D578UVII Firmware Changelog

D578UVII firmware update V2.04 (dated 2022-12-8)

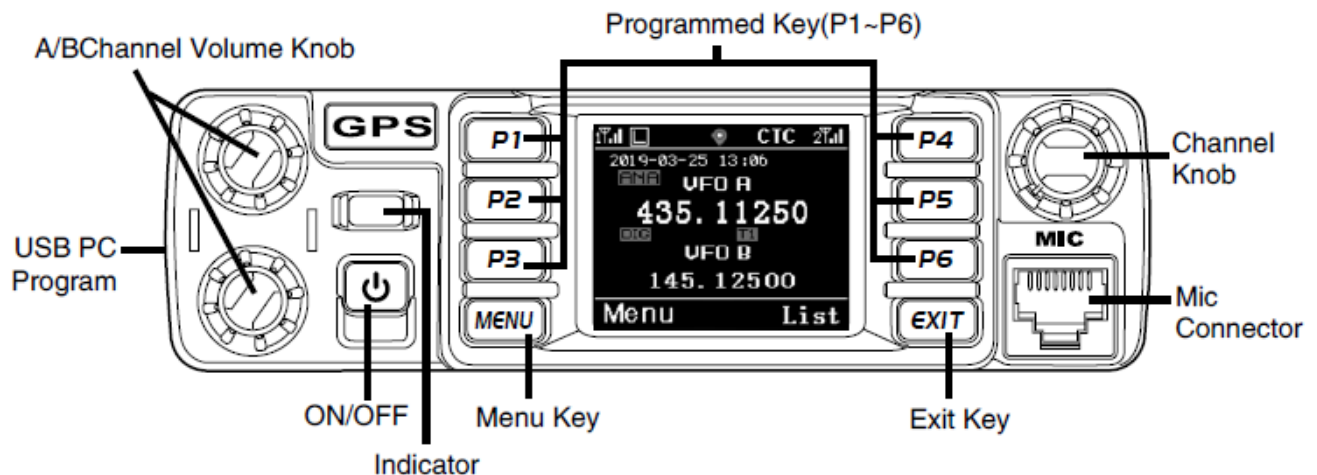
1. CPS->Optional setting ->Display->Date Display Format, allows the user set the date format on display.
2. CPS->Optional setting ->Display->Display Channel type, allows the user turn off the channel type on display

3. CPS->Optional setting ->Display->Display time slot, allows the user turn off the time slot on display
4. CPS->Optional setting ->Display->Display color code, allows the user turn off the color code on display

5. CPS-> Optional setting ->Alert Tone, add Ana idle channel tone, the digital channel and analog channel have separated idle channel tone setting.
6. CPS->Channel -> Auto scan, tick on the box will allow the radio start scan automatically.

7. CPS-> Optional setting ->Volume/Audio, separate mic gain setting for digital channel and analog channel
8. CPS-> APRS ->Ana AprsTX, allows to set wide band or narrow band for analog APRS transmit.

9. Add the alert tone setting in radio menu.
10. CPS->Analog -> 2Tone Setting-> Auto Reset Time changes to maximum 250S. If you set Auto Reset Time to 25s, it keeps the squelch on carrier until there is 25 secs of silence, then it switches back to waiting for tones. If there is a transmission before the end of that 25 secs, the timer restarts. It is useful for the 2Tone Paging System.

11. CPS->Analog -> 5Tone Setting-> Auto Reset Time changes to maximum 250S
12. CPS->Analog -> DTMF-> Auto Reset Time changes to maximum 250S

13. CPS->Optional Setting ->AM/FM -> AM squelch, allows to set the AM squelch separately.
14. Rename to AM menu to AM air.
